From the Vancouver Fraser Port Authority re: Requirements for Information Pertaining to Changes to the Roberts Bank Terminal 2 Project

ROBERTS BANK TERMINAL 2 PROJECT

Project Construction Update

ROBERTS BANK TERMINAL 2	
	TERMINAL 2 OVERPASS EAST STRUCTURE CONCEPTUAL LAYOUT	
	DATE: 06/06/2018	FIG No. 4-33

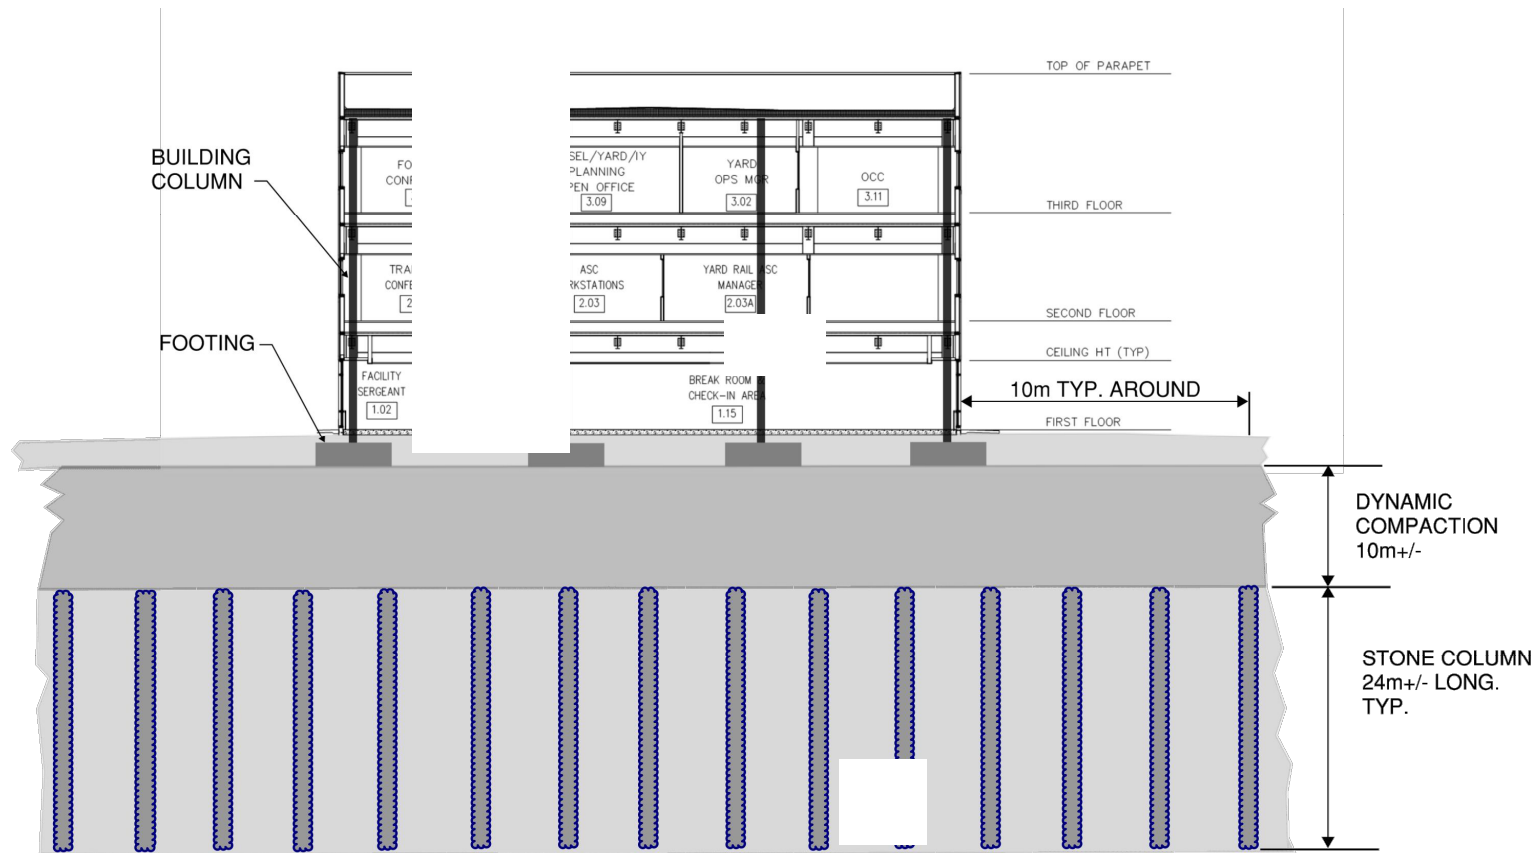
For the overpass, the conceptual design was further advanced incorporating the latest version of the bridge code, CAN/CSA-S6-14, as shown in **Attachment A**, New Figure 4-32 and **Attachment A**, New Figure 4-33. **Attachment A**, Updated Figure 4-7 shows the updated overpass and road connection. Land-based vibro-replacement densification of native and reclaimed soils will be carried out around the piled area and beyond the footprints of the overpass structures. The overpass will be founded on approximately 86 steel pipe piles driven from land to El.-20 m CD. Pile installation may require both a vibrator and a hammer (vibratory for the initial depths and hammer for the final set and blow count testing). Depending on the construction methodology applied, the overall pile installation duration will vary and may take up to 60 days, during daylight hours.

TYPICAL SECTION - ADMINISTRATION BUILDING

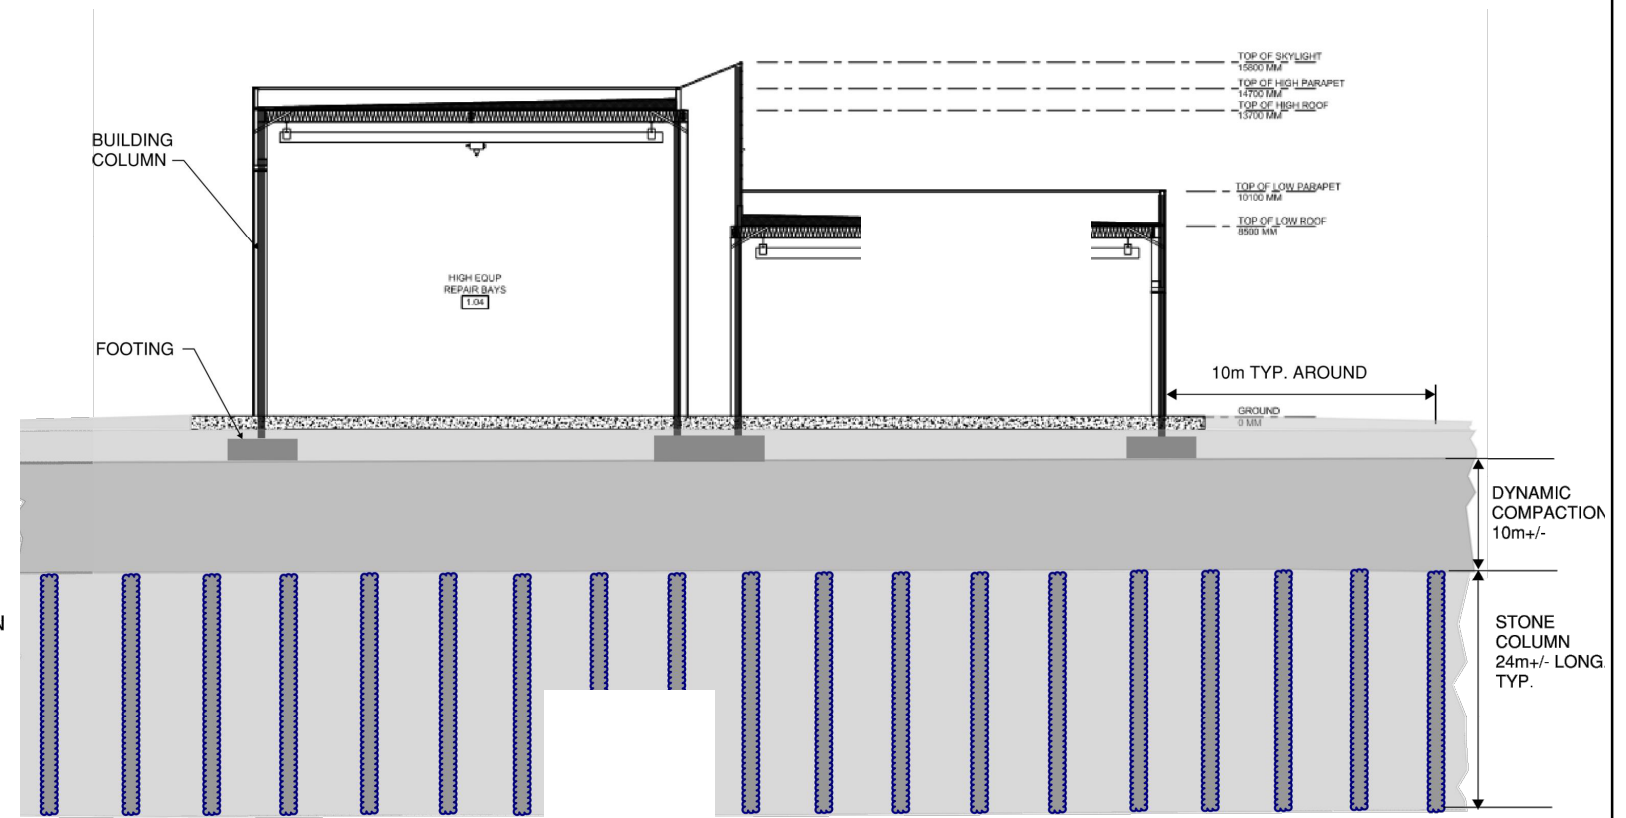
Similarly, the depth of the vibro-replacement underneath the buildings (to be located at the east end of the terminal) has been reduced by approximately 8 m, meaning that this process can now be completed from the newly formed land in the dry. Fines will be captured on the surface and directed into remaining fill sites. (Refer to **Attachment A**, New Figure 4-34 for terminal building conceptual cross section.)
